# TECHNICAL BULLETIN

DS7, R5's, RD250, RD350

CLUTCH, Elimination of Slipping

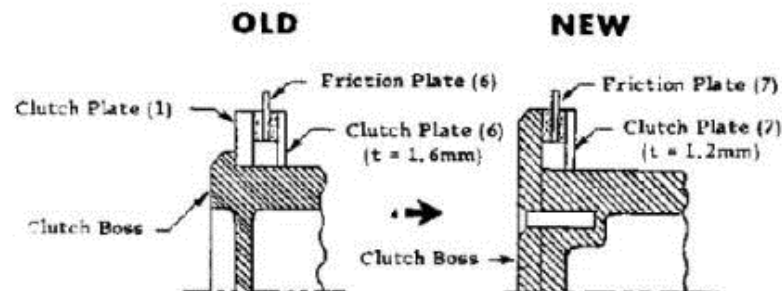
Clutch assemblies on above models have been redesigned to reduce clutch slippage. This change consists of replacing the clutch boss and clutch plates and increasing the number of friction plates from six (6) to seven (7). See table below for both old and new parts list.

The clutch must be assembled with the first friction plate against clutch boss. See drawings below.

CLUTCH, Elimination of Slipping (cont.)

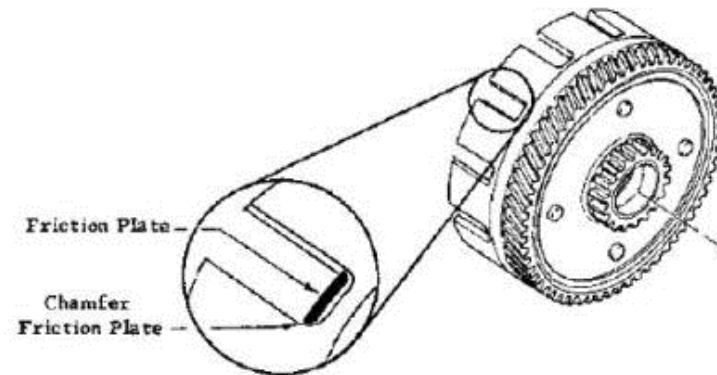
When clutch is fully assembled with pressure plate and spring screws installed, check to see if first friction plate is touching clutch hub (Primary Driven Gear Complete). If friction plate is touching, it will be necessary to chamfer edges of friction plate to provide clearance. Do not remove metal from corners of clutch hub. See drawing below.
